## APPENDIX D ENVIRONMENTAL PLANNING INSTRUMENTS

### 1.2 SEPP 65 – Design Quality of Residential Flat Development and Compliance with the RFDC

Figure 10: Non-Compliances with Riverbank Site Controls

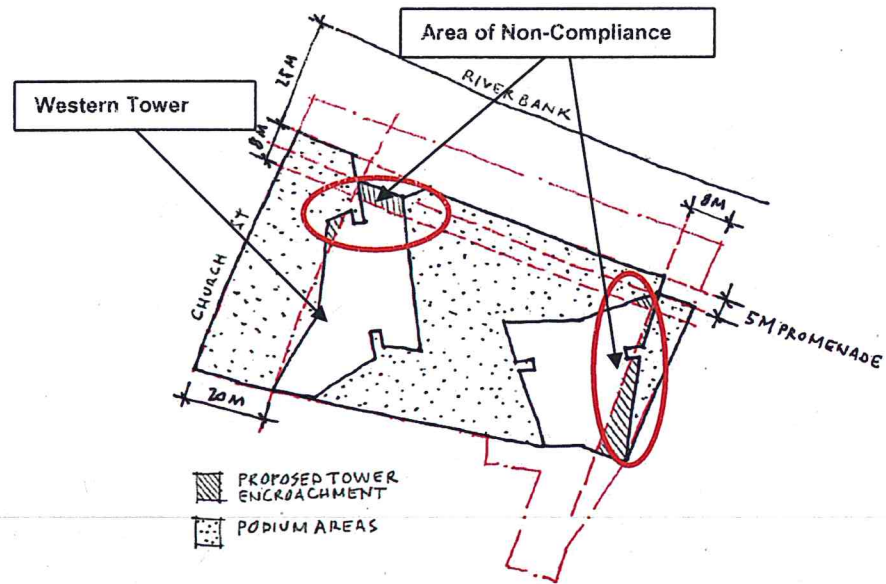
Notwithstanding, the department notes that there will be minor non-compliances with the setback controls outlined in the Riverbank Site controls as depicted in Figure 10 below.

This non-compliance is a result of the building being 'creased' in both plan and elevation. The department considers this non-compliance acceptable on the basis that the 'creasing' of the building provides a sculptural built form, and assists in providing an appropriate bulk and scale for the northern gateway of the CBD.
